**Re: Humboldt Bay Repowering Project (06-AFC-07):**  
**Responses to CEC Staff Data Requests 79-85 and Workshop Queries 5, 6, 8-11, and 13**

**Responses to CEC Staff Data Requests 79-85 and  
Workshop Queries 5, 6, 8-11, and 13**

**Humboldt Bay Repowering Project**

(06-AFC-7)

Figure 1  
Locations of the PM<sub>10</sub> Increment-Consuming Sources

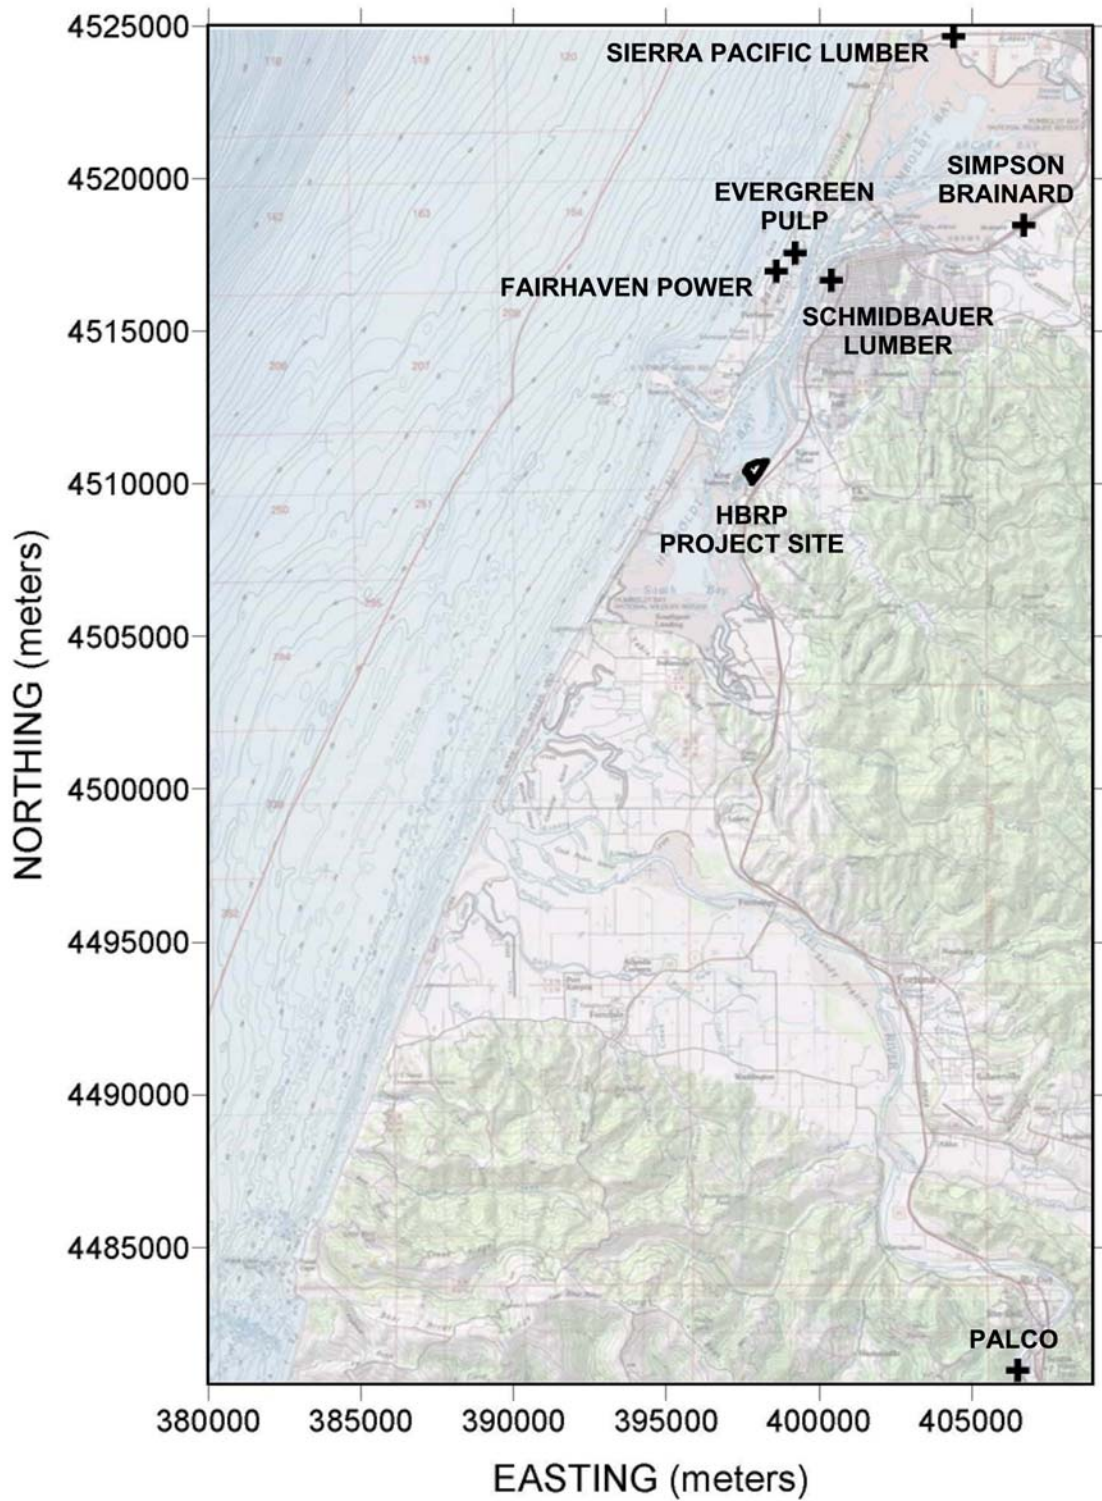
WSQ-6 *Please provide a status report on the analysis of significant sources for the PSD increments analysis.*

Based on the results of the screening-level modeling described above, only one of the 4 facilities located more than 5 km from the HBRP significant impact area was identified as having potentially significant PM<sub>10</sub> impacts within the HBRP significant impact area. The emission rates and stack parameters used for modeling this source, along with the five facilities that are closer to HBRP, are shown in Attachment 4. The locations of the facilities are shown in Figure 1.

**FIGURE 4A**  
**WETLAND DELINEATION**  
**USACE METHODS, REVISED**  
**FEBRUARY 2007**  
**HUMBOLDT BAY REPOWERING PROJECT**

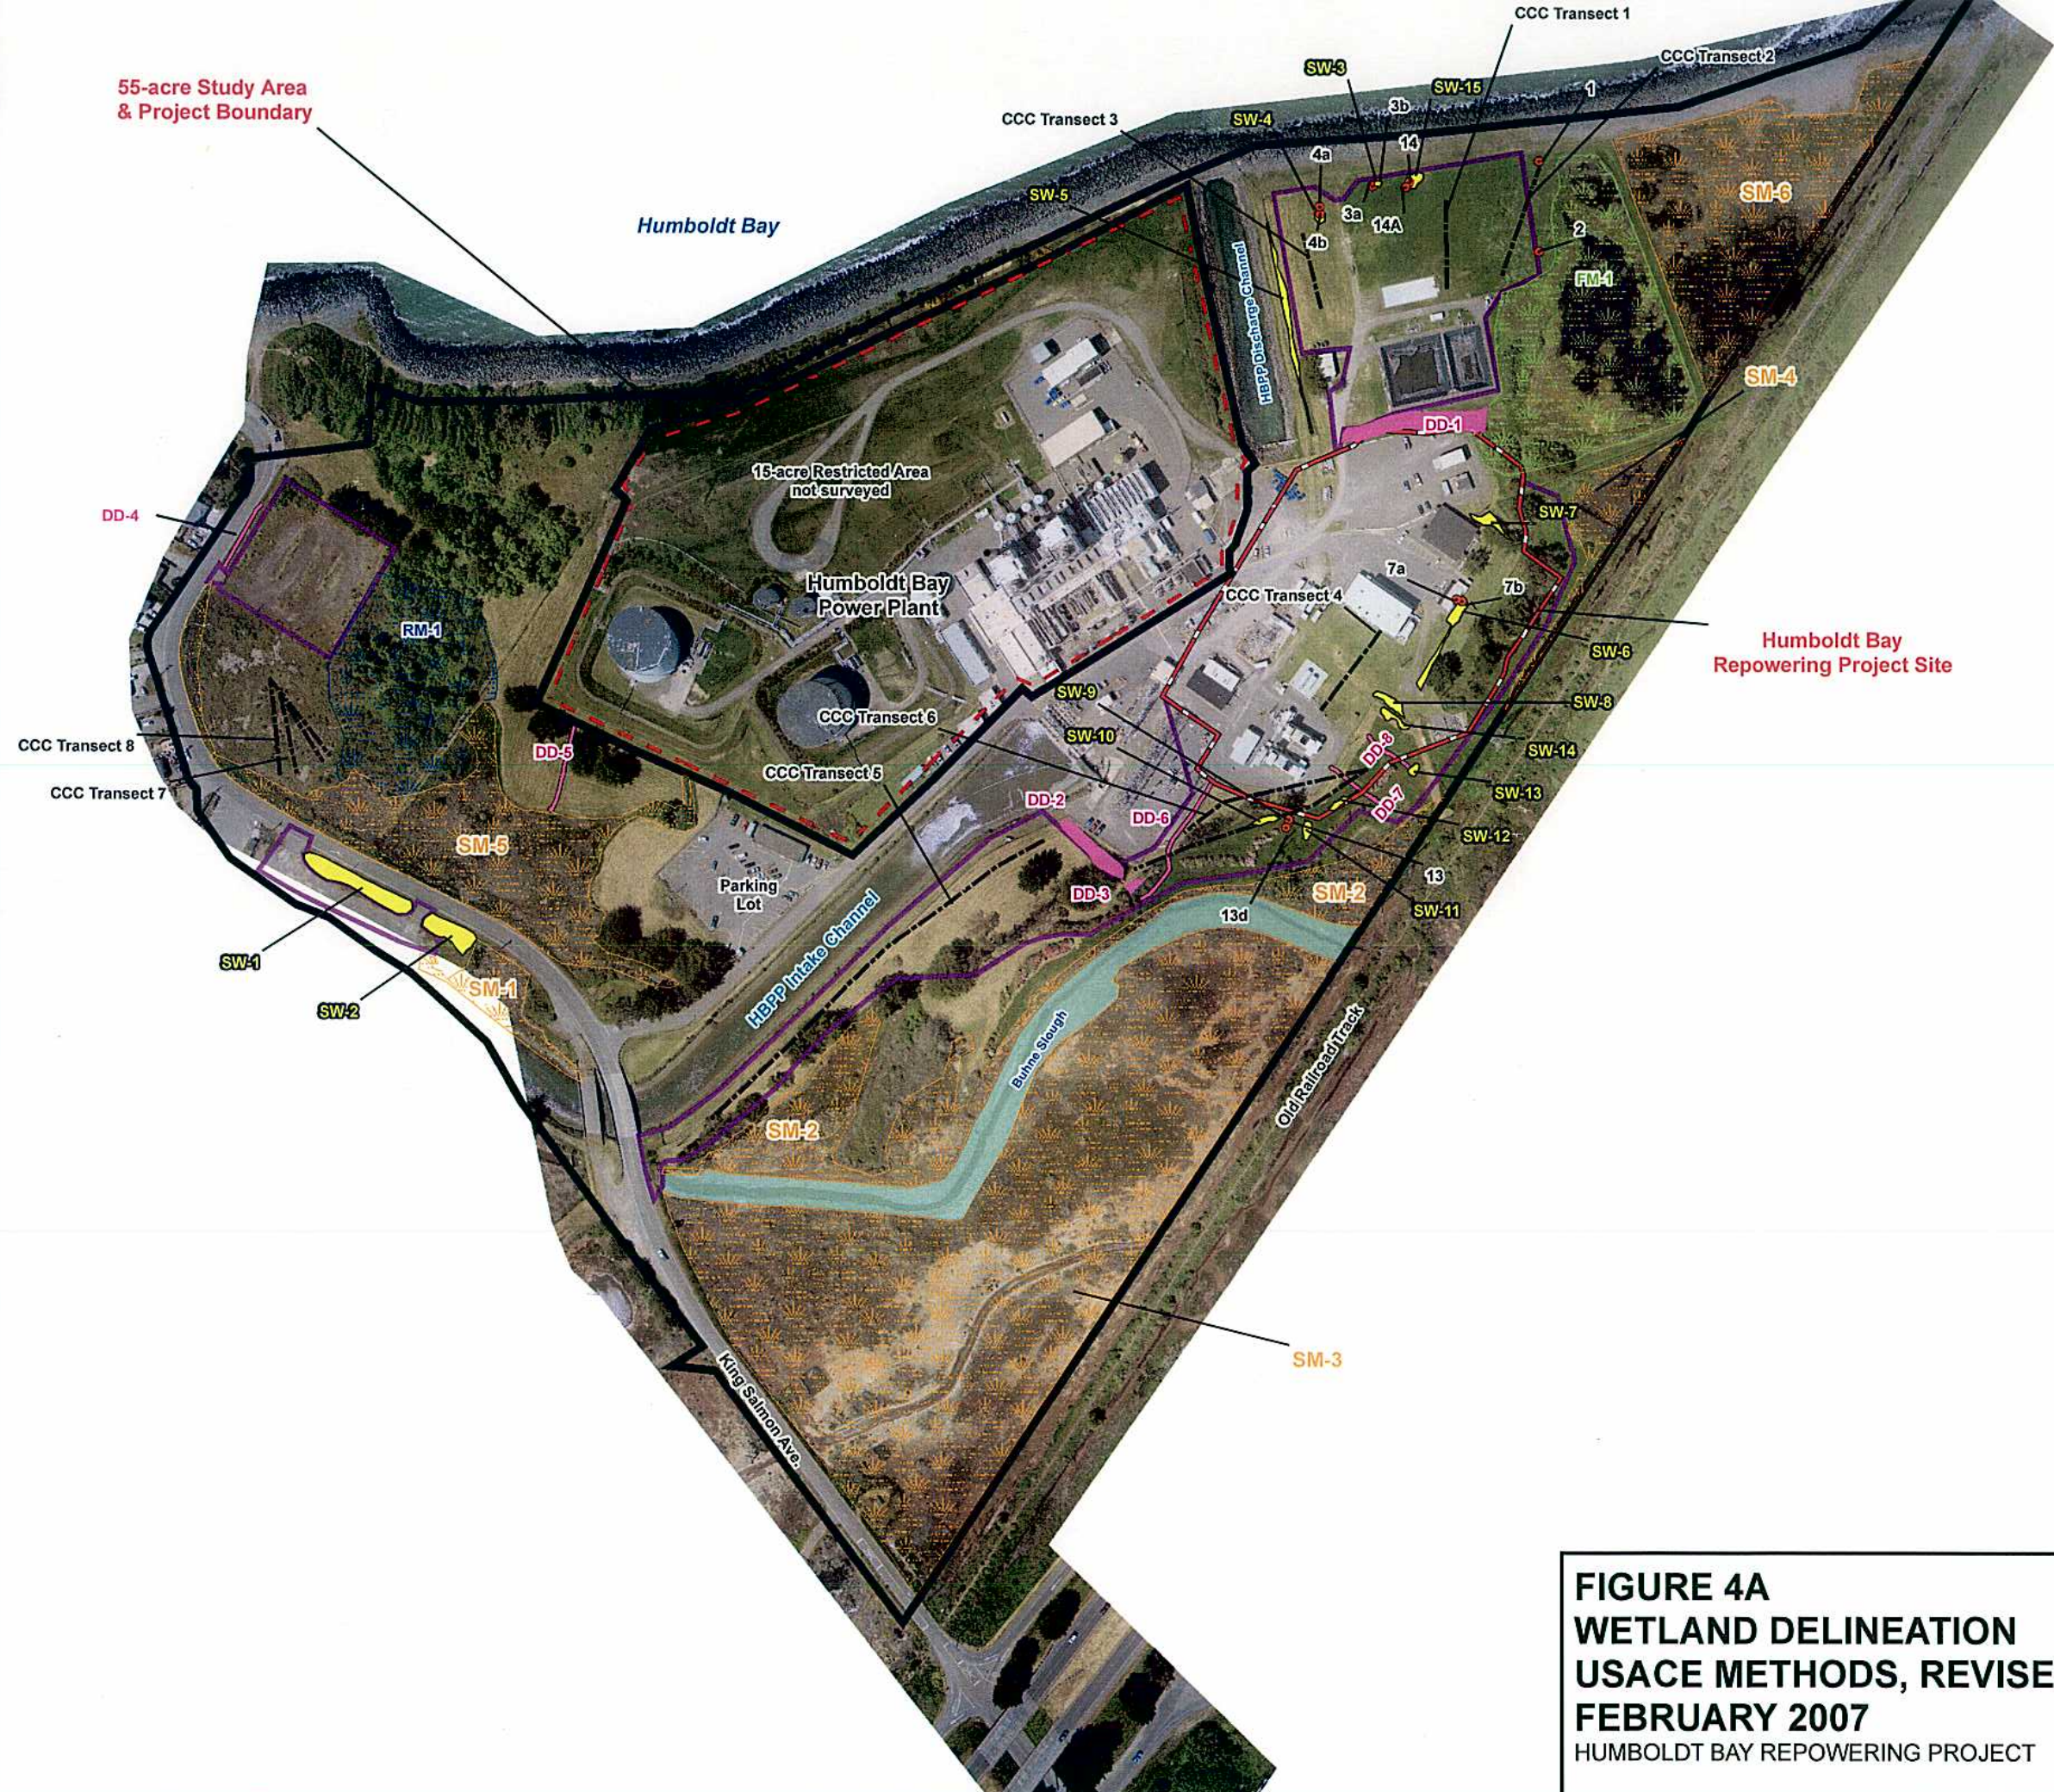
WSQ-9 *Please provide a revised wetland mitigation map showing only wetlands under the potential jurisdiction of the U.S. Army Corps of Engineers (USACE).*

**Response:** The map of wetlands under USACE jurisdiction is provided as Attachment WSQ9-1.

This brings our revised USACE jurisdictional wetland acreage on the project site from 20.646 acres to 20.671 acres. We have made these adjustments in the project documentation and will carry forward these figures to future estimates of impacts and mitigation requirements.

**Attachment DR80-1**  
Wetland Mitigation Areas

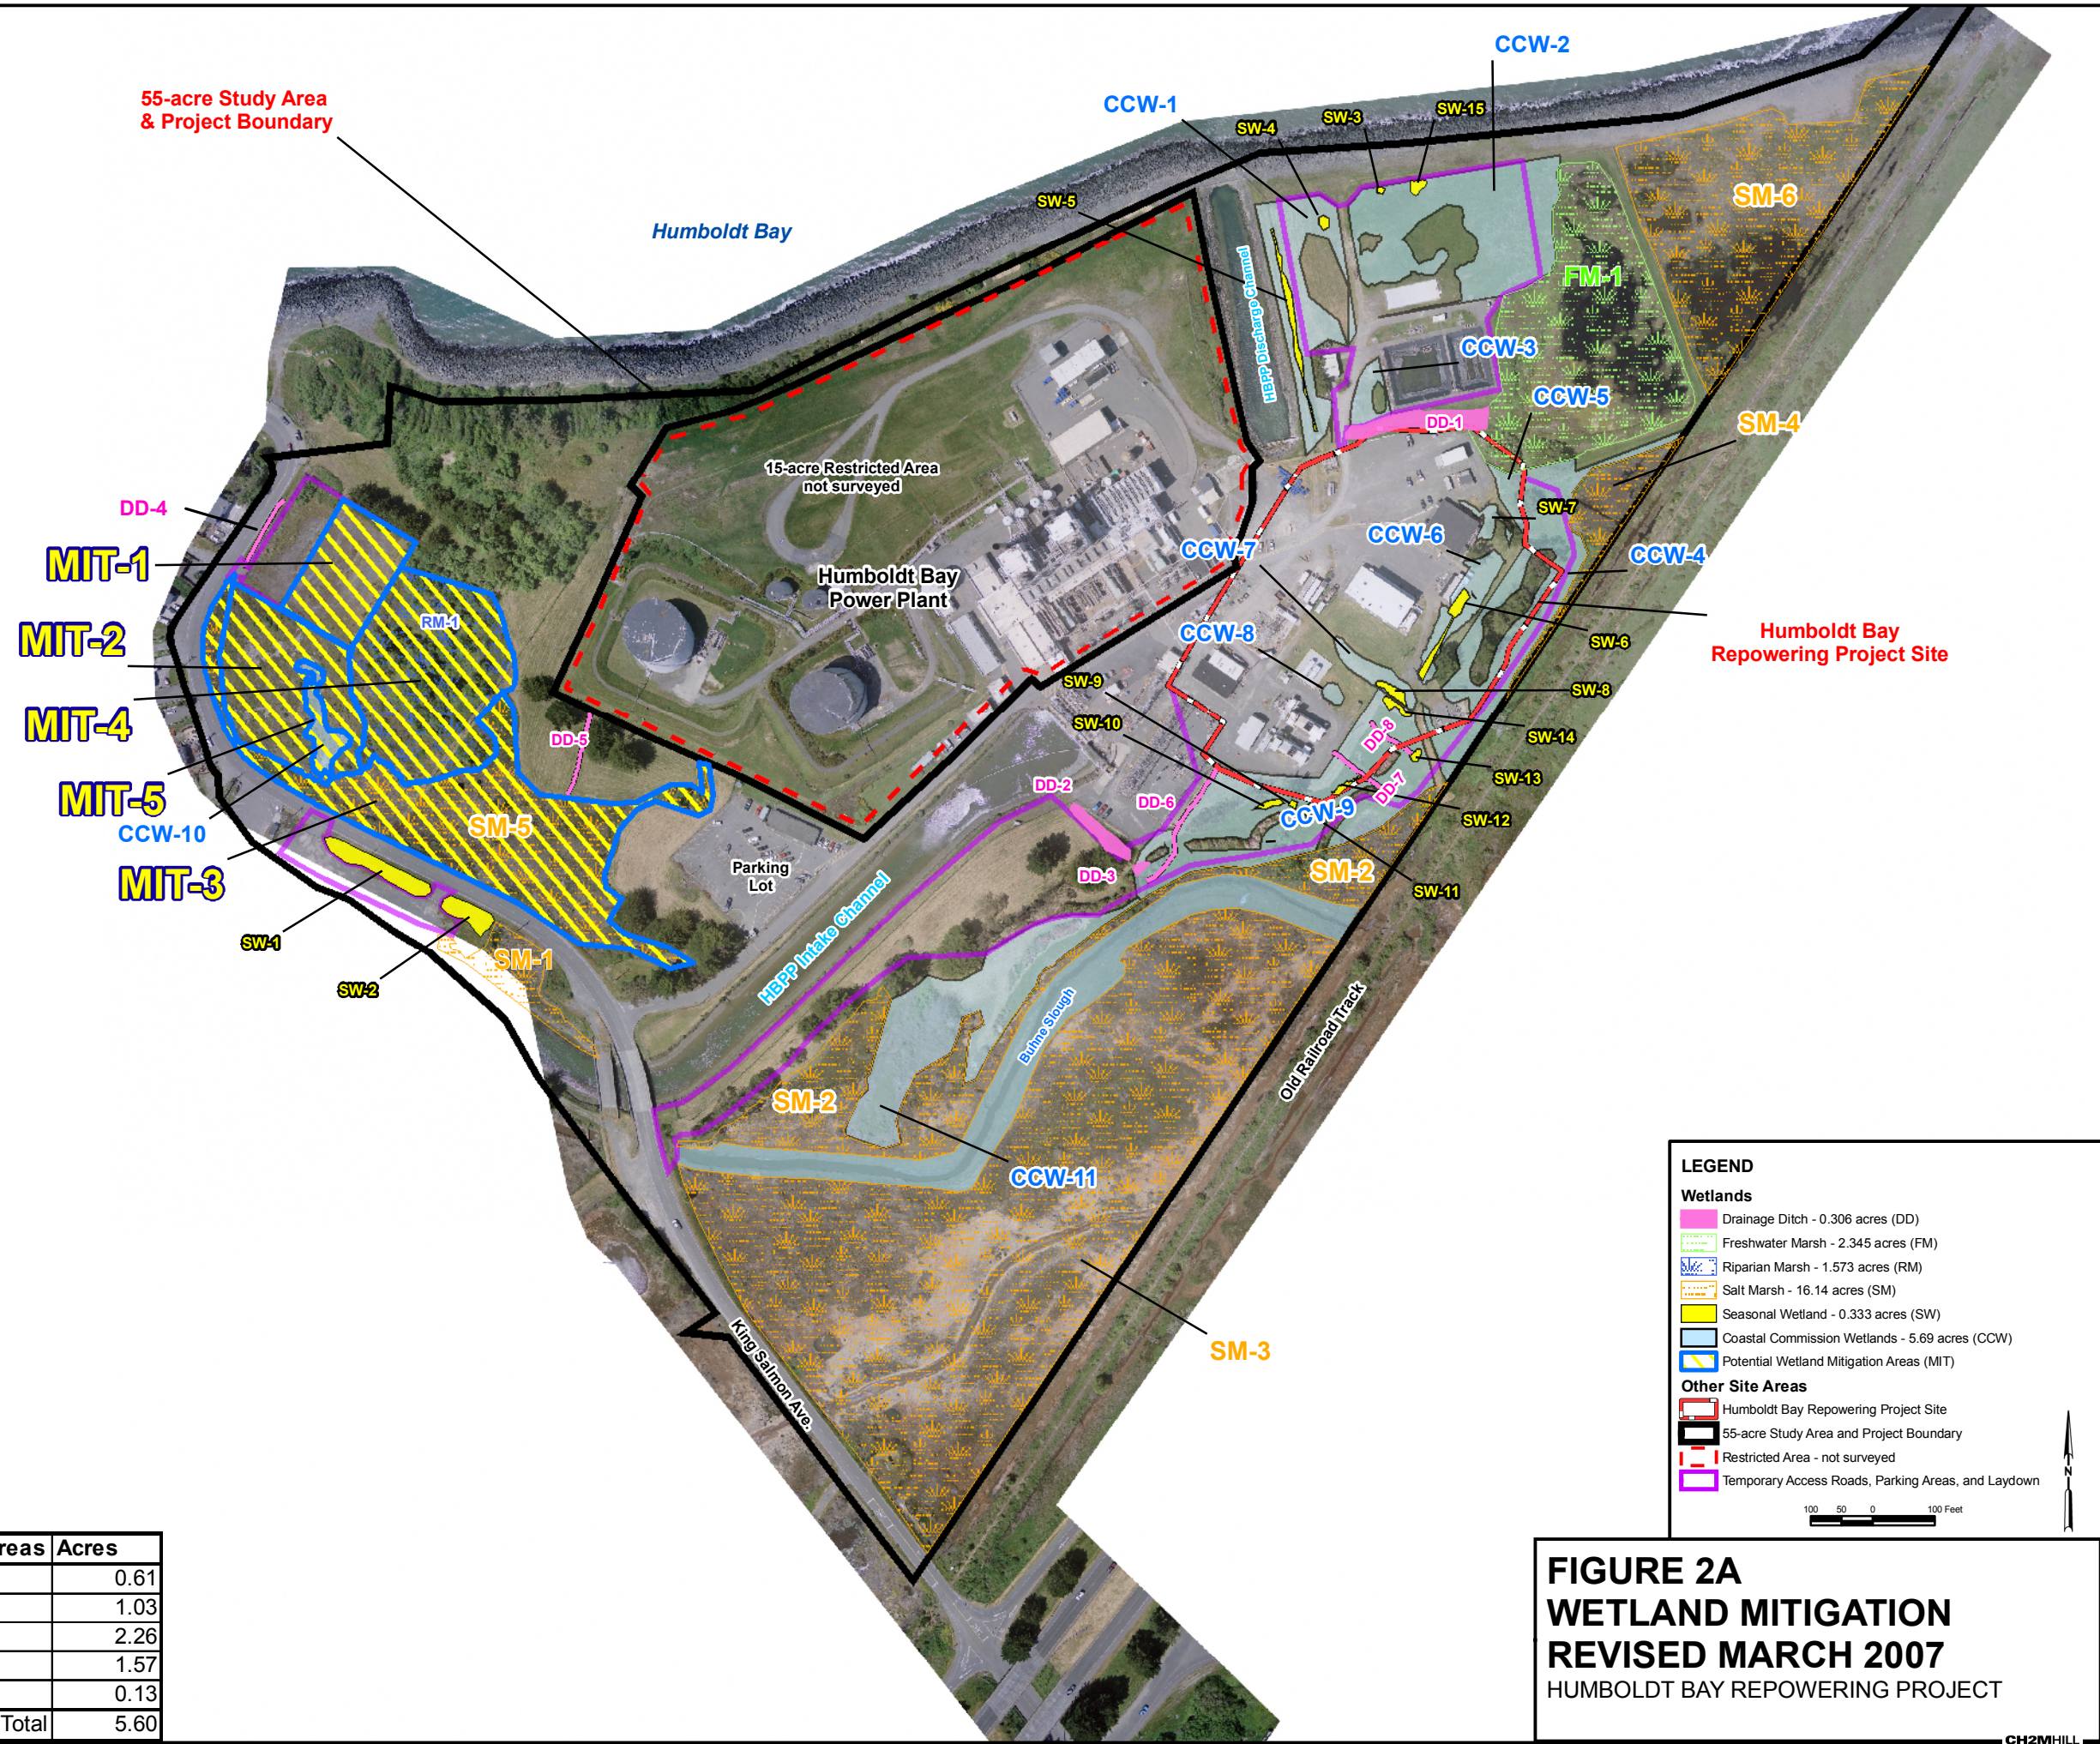
80. *Please provide the following:*

a) *Indicate whether all of the areas proposed for wetland mitigation sites will be placed under permanent conservation easements. If all of the areas proposed as wetland mitigation sites will not be placed under permanent easements, please provide the total acreage of land that will be given easement status.*

b) *Provide a map of the areas that will be placed under conservation easements.*

**Response:** The proposed wetland mitigation areas are shown in Figure 2A of Attachment DR80-1 (see Biological Resources, later in this document). The mitigation plans for these areas are discussed in Section 8.2.4.6 of the AFC. The mitigation activities are proposed to be carried out in two stages: (1) during initial construction of the new access road, and (2) after the remote parking area is no longer needed for parking and a portion of this area can be used for wetland mitigation. Because the mitigation will be carried out within areas that are used during project construction, most mitigation activities will not occur simultaneously with construction activities.

**Response:** The areas identified on Figure 2A (labeled MIT-1 through 5) are proposed as wetland mitigation sites for the HBRP project (included as Attachment DR80-1). Figure 2A shows the mitigation areas that will be placed under a deed restriction. These areas total 5.6 acres. As specified in the AFC, the mitigation areas would be protected "in perpetuity through a conservation easement or other land use restriction determined and implemented by PG&E." PG&E proposes to place the mitigation areas under a deed restriction rather than a conservation easement.
